6-30 Artarmon Rd Willoughby Review

Concept Plan Review

Prepared for Willoughby Council
September 2016

**OFFICE OF GOVERNMENT ARCHITECT RESPONSE - REQUEST TO MODIFY THE CONCEPT
PLAN APPROVAL FOR 6-30 ARTARMON ROAD, WILLOUGHBY (FORMER CHANNEL 9 SITE)**

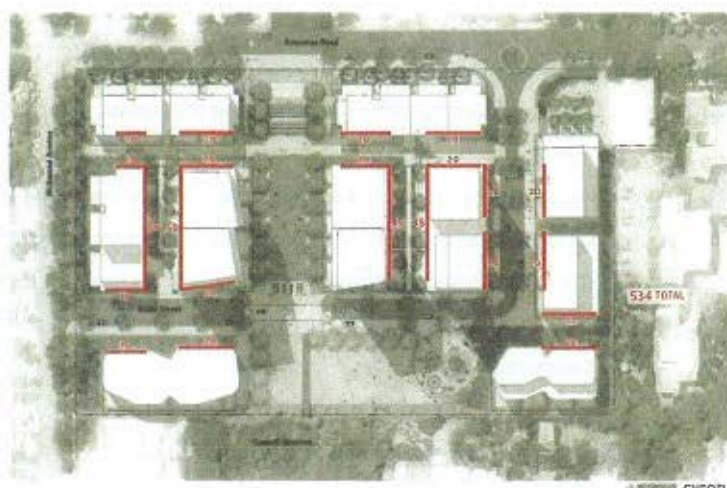
- Building separation requirements more specifically, have also been adhered to. However the diagrams above illustrate the general impact that the overall change in density has on the collection of built forms, in a way that goes beyond the minimum requirements of the Apartment Design Guide. The building frontages highlighted in red denote where a building facade is facing another building less than 25m away, in the proposed concept plan on the left and the approved plan on the right.

- Although many of the proposed units face onto the new public spaces and Scott Street, and not into the narrower communal spaces, there is a marked increase from the approved scheme in the length of building forms that face other building forms.

- Whilst the minimum separations have been achieved, we believe the resulting outlook from many units will be of lesser quality. And that more broadly, the collection of built forms in the proposed concept plan will appear too closely spaced when viewed from the new public domain on the site.

- We acknowledge that modification of the building forms to reduce the negative affect of consistently providing minimum building separations may result in the loss of some units from the number proposed in the concept plan ammendment.

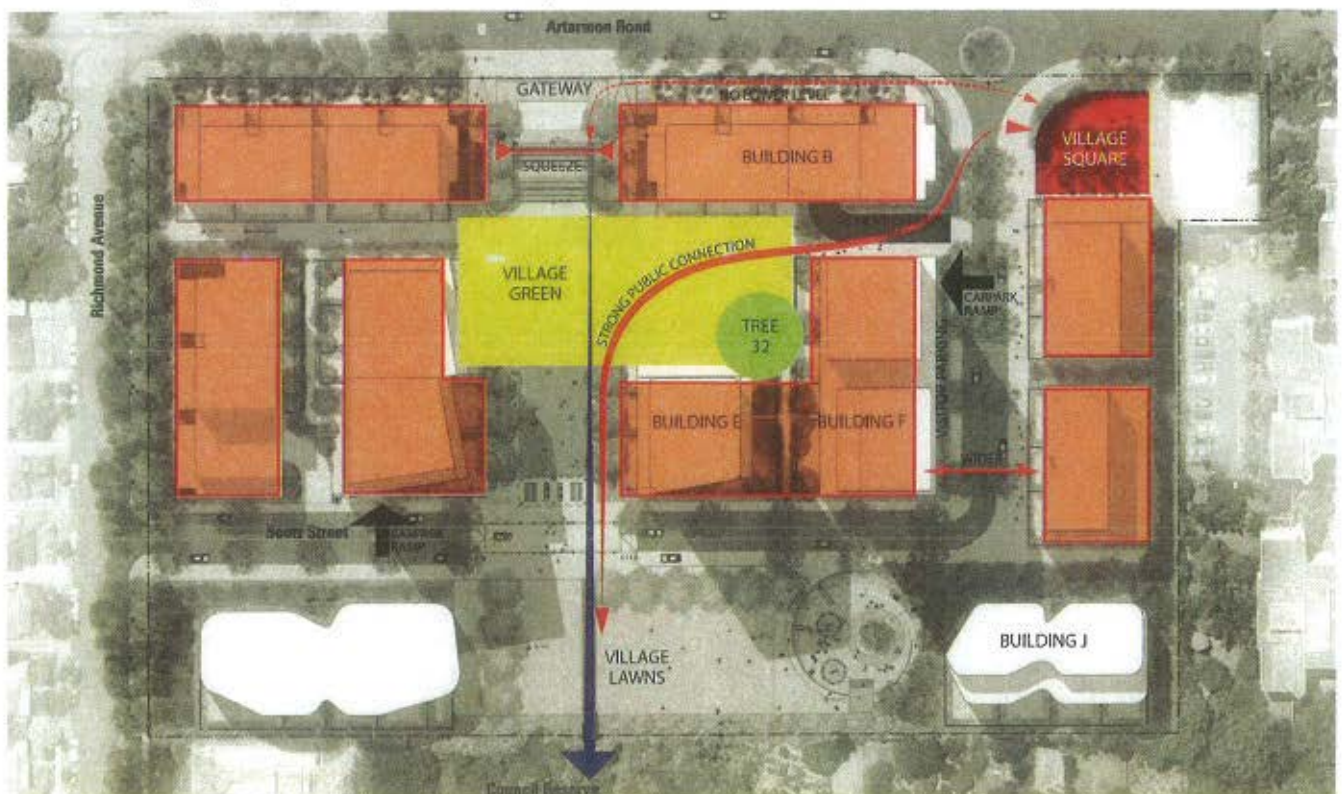
- The provision of a single entry/exit point for the subterranean parking of 510 units can prove to be problematic in our experience. The vehicle access point provided is well located on the site, but it limits the sense and understanding of address for residents. The further a resident lives away from the point of entry to the carpark, the greater this effect will be.
- Additionally, this single vehicle access point can lead to congestion within the site carpark at peak times.

8. The proposed vehicular entry near Village Square should be moved to conceal it in/under a built form and minimise encroachment on open spaces/site linkages.

9. A second vehicle access point to the subterranean parking that improves the sense of address and traffic impacts in peak times should be provided.
10. The building separation along Scott Street should be widened to allow for a larger provision of kerbside visitor parking.
